**LOCAL HISTORIC DISTRICT:** Wilmore

**PROPERTY ADDRESS:** 1740 Wilmore Drive

**SUMMARY OF REQUEST:** Siding Changes

# HDCRMI 2019-00517

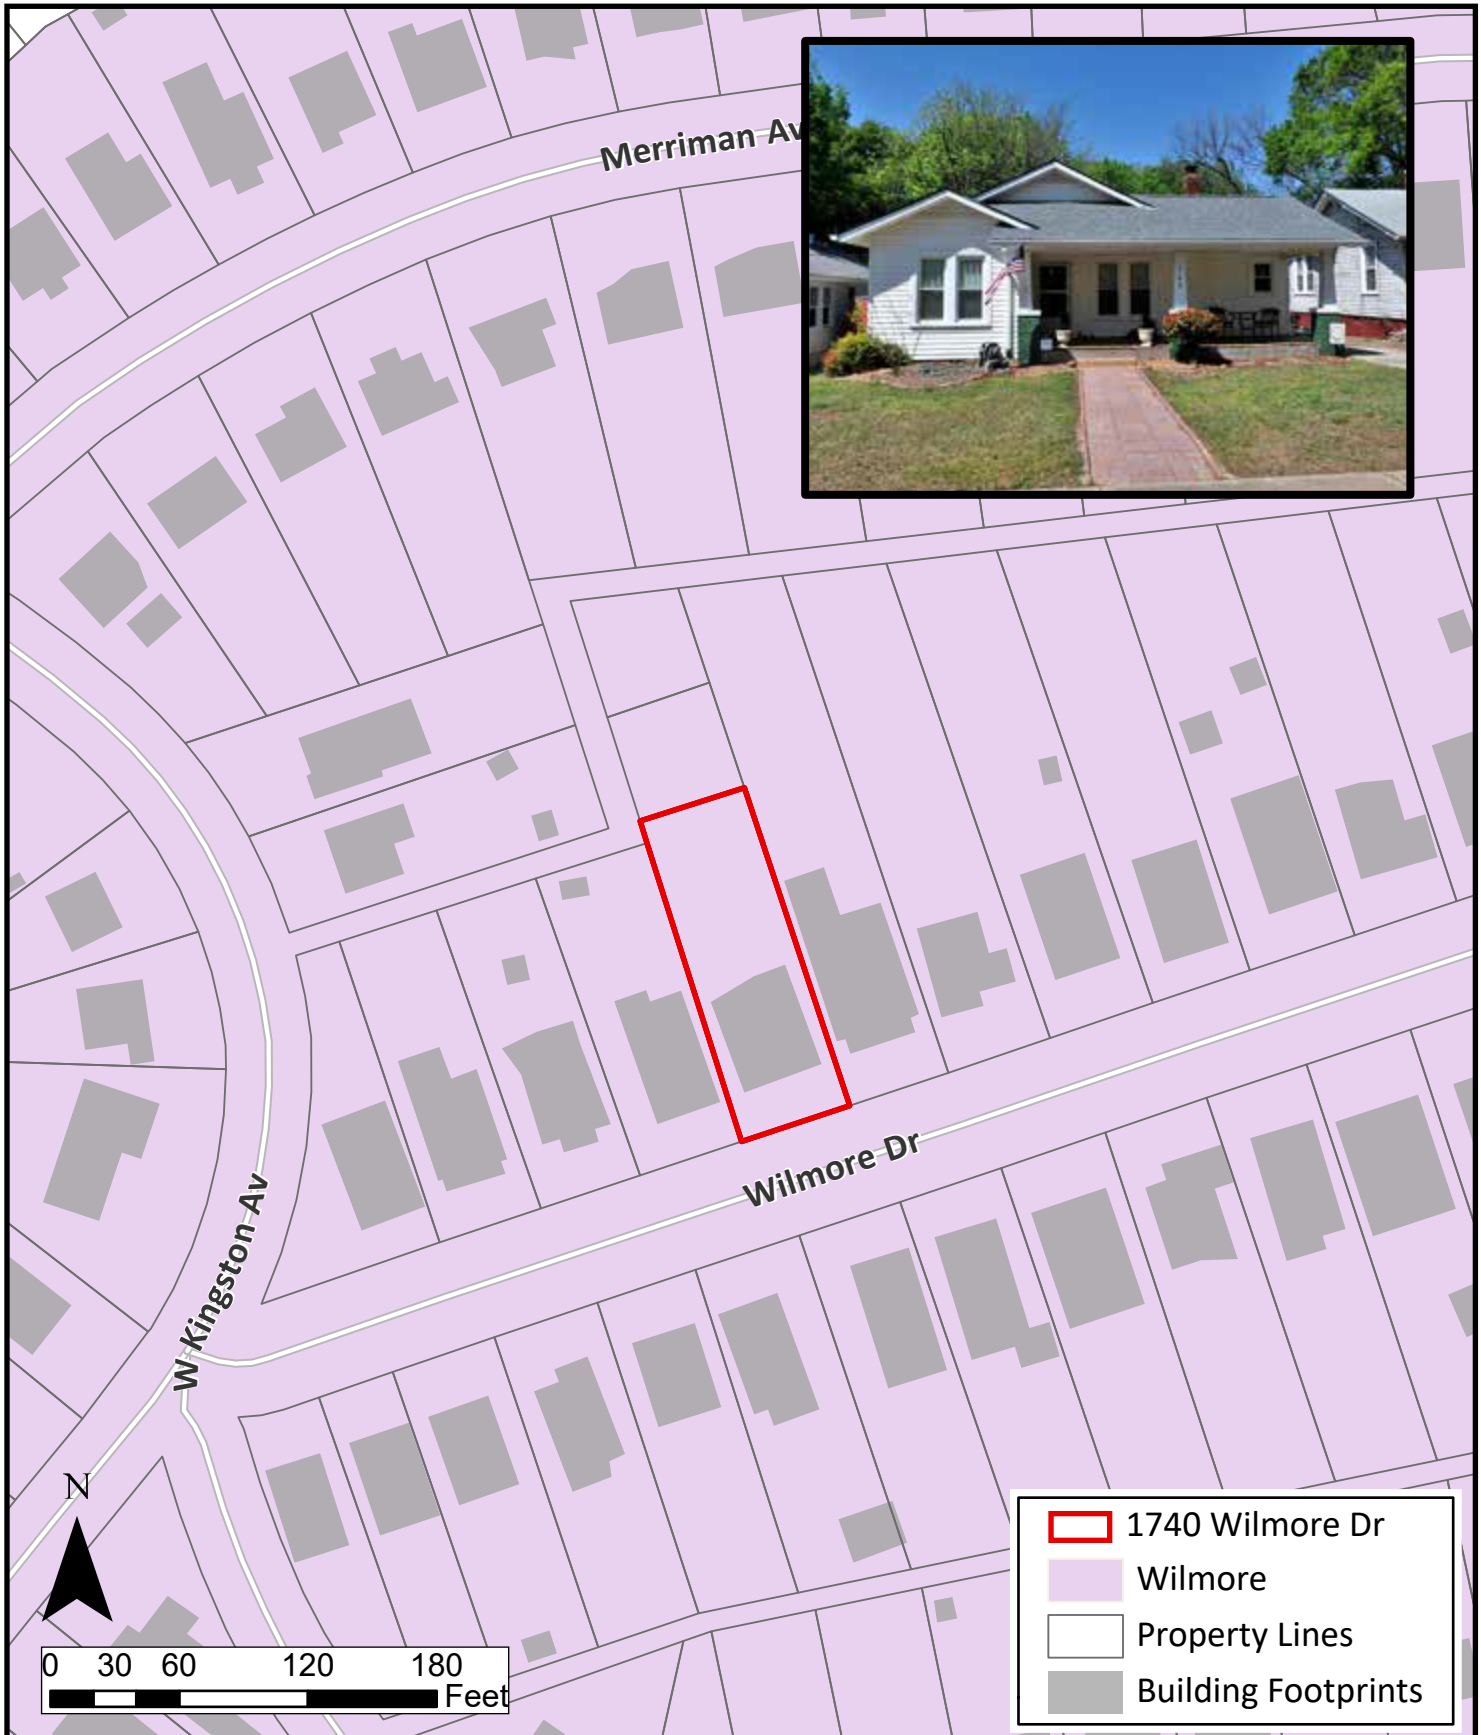
Staff has the following concerns with the proposal:

1. At the time of approval for the Accessory building (shed), the entire house was covered in vinyl siding with corner boards.
2. Window trim is picture frame on the rear elevation.
3. Minor revisions may be reviewed by staff.
